A.2. MANOR HILL COMMUNITY PROJECT

Site Plan, Special Use Permit and Aquatic Resource Permit Hearing for a proposed manufactured home community comprised of 14 lease lots. The project includes a new access road from North Grand Avenue into the existing Manor Hill Mobile Home Park, and water and sewer services via connection to existing Town facilities. 246 North Grand Avenue; Zoned R-MH (Residence, Mobile Home) District; ± 5.53 acres; Grid # 6162-16-970397; Type I Action; *Manor Hill Mobile Home Park, Owner.*

Project Name: MANOR HILL COMMUNITY PROJECT
Parcel ID #(s): 6162-16-970397-0000
For Planning Board Meeting on: February 19, 2026

DATE: FEBRUARY 26, 2024
SCALE: 1" = 30'
JOB NUMBER: 17-24
SHEET NUMBER: C601

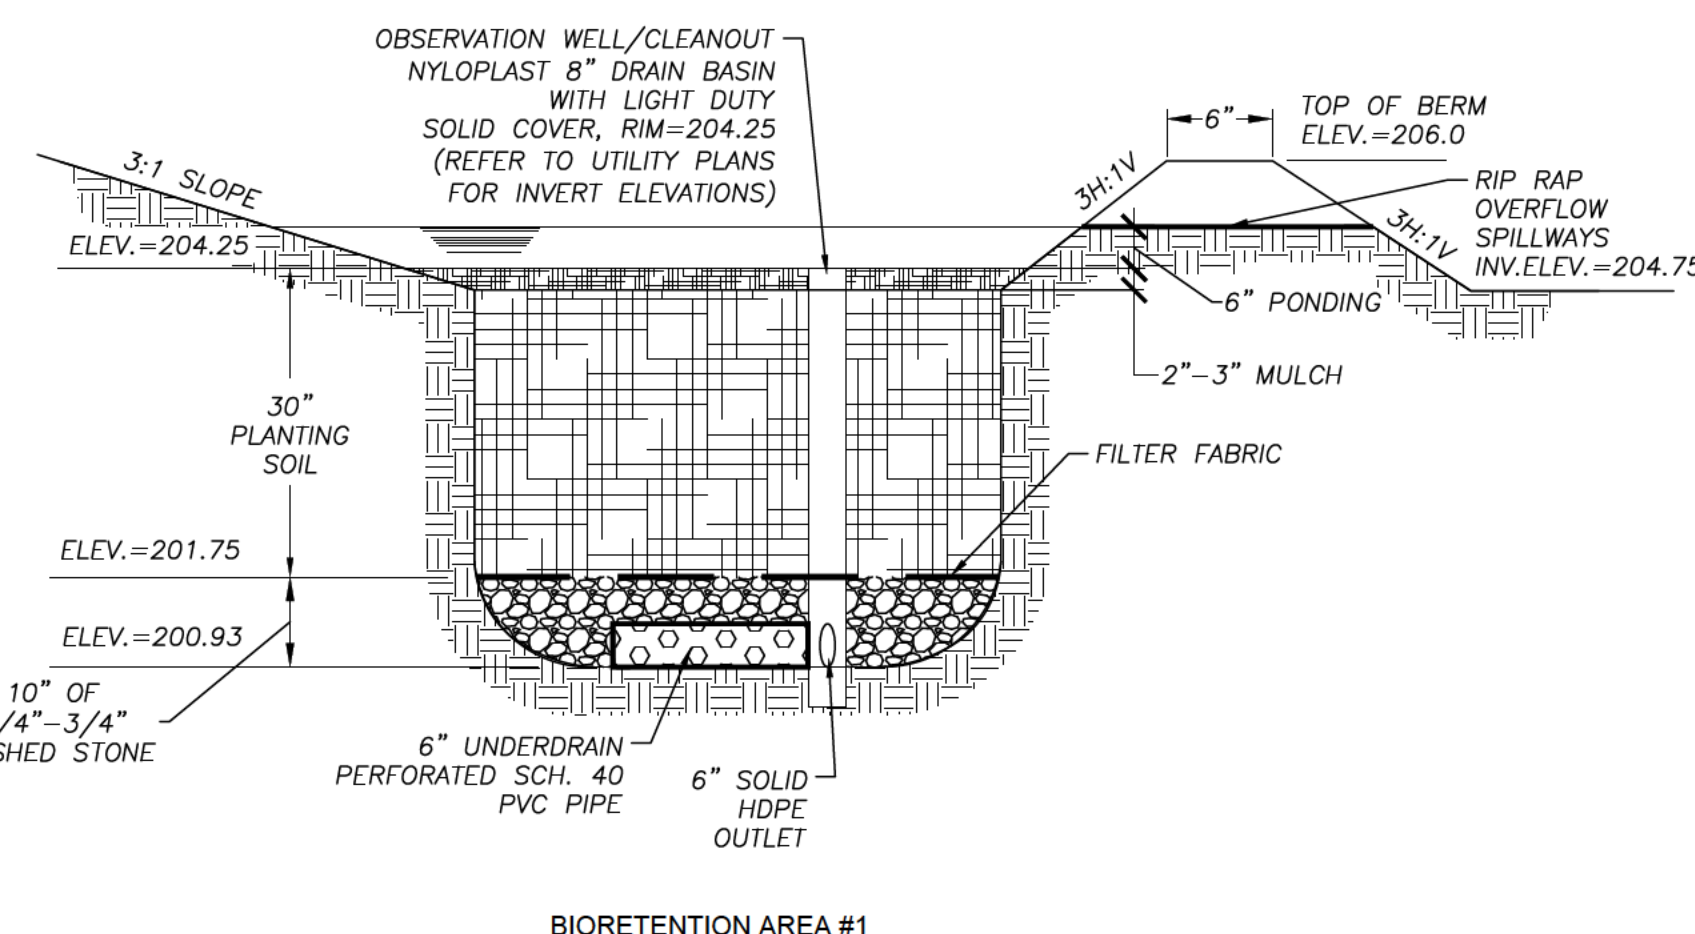
Installation of the temporary turtle exclusion fence should be included in the sequence schedule notes indicated on the Erosion and Sediment Control plan (C601), not just the Blanding's Turtle Construction Sequence notes (C703), so as not to be overlooked. Both such notes must indicate the installation of turtle exclusion fencing by April 15, prior to the turtle's anticipated active season.

In accordance with the ACOE permit, grading and planting of the wetland mitigation area must be completed prior to the discharge of fill authorized by the permit. Thus the sequencing notes must reflect this. Wetland mitigation is currently #12 on the Erosion and Sediment Control Plan sequencing notes.

Response: The revised plans indicate proposed locations for bladings turtle protection fence on Sheet C601. Construction details and notes describing required schedule & turtle monitor requirements are provided on Sheet C703.

C703

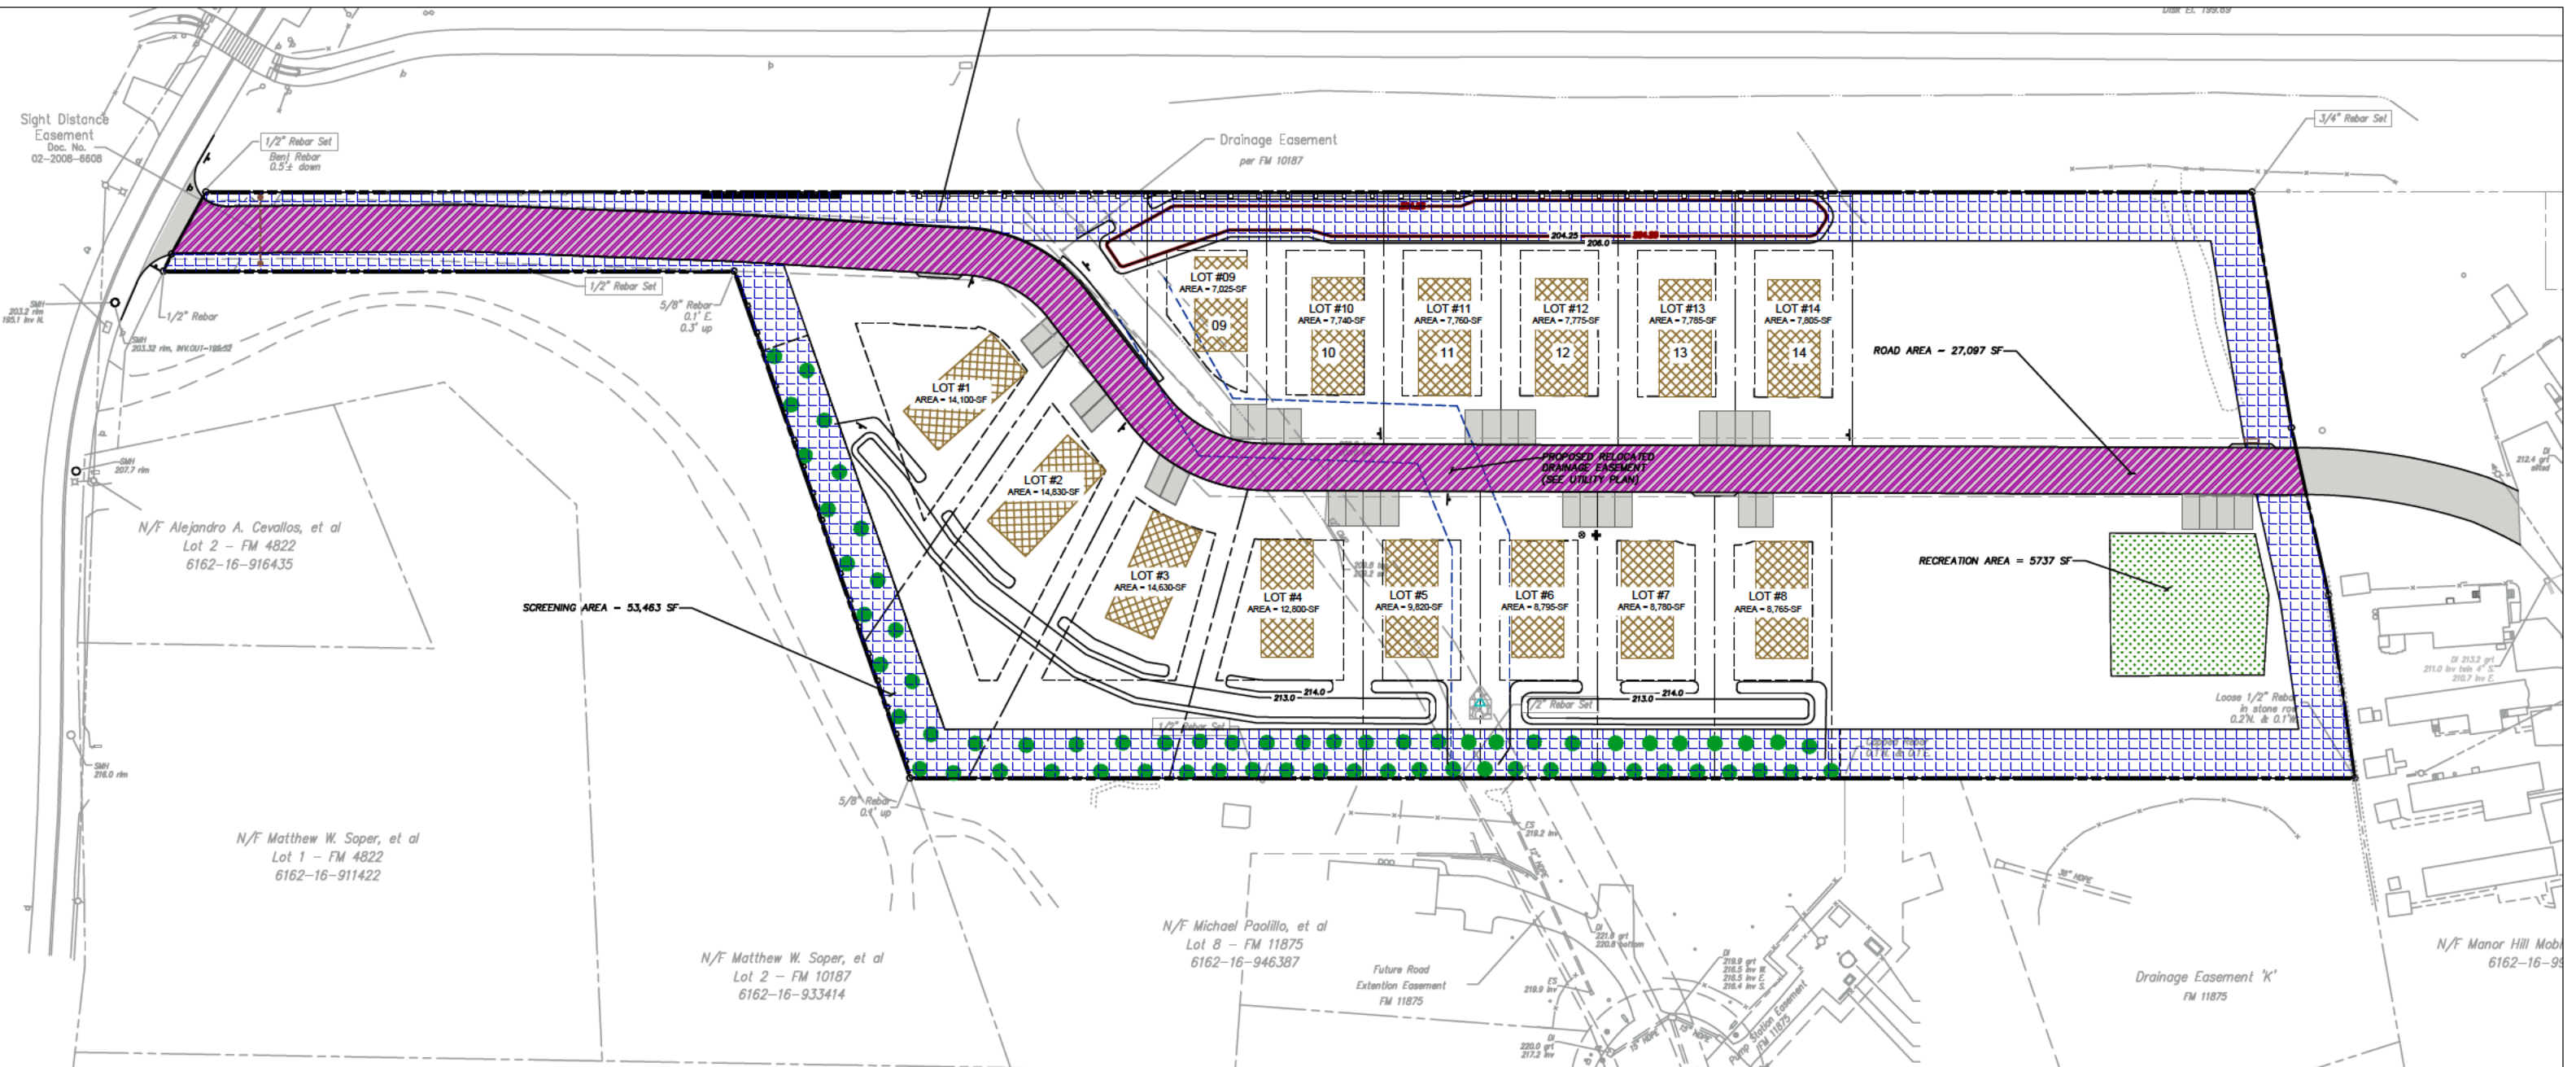
2) The temporary turtle barrier indicated on the site plan must include gates with bottom sweeps and must remain closed during the turtle's active season; gate signage is recommended.

plan. The plan must also indicate exclusionary gates, at each construction entrance, with a lower sweep. The gates should be installed such that the default position is closed; signage should be included on the gates indicating that the gates are to remain closed at all times between 4/15 and 10/15 for the protection of Blanding's turtles.

Blandings Turtle Construction Sequence notes 4 and 5 on the plan refer to utilizing stockpiled soils for Blanding's turtle nesting area. I do not recall any proposed nesting areas nor do I find any on the plans. These final comments should be addressed.
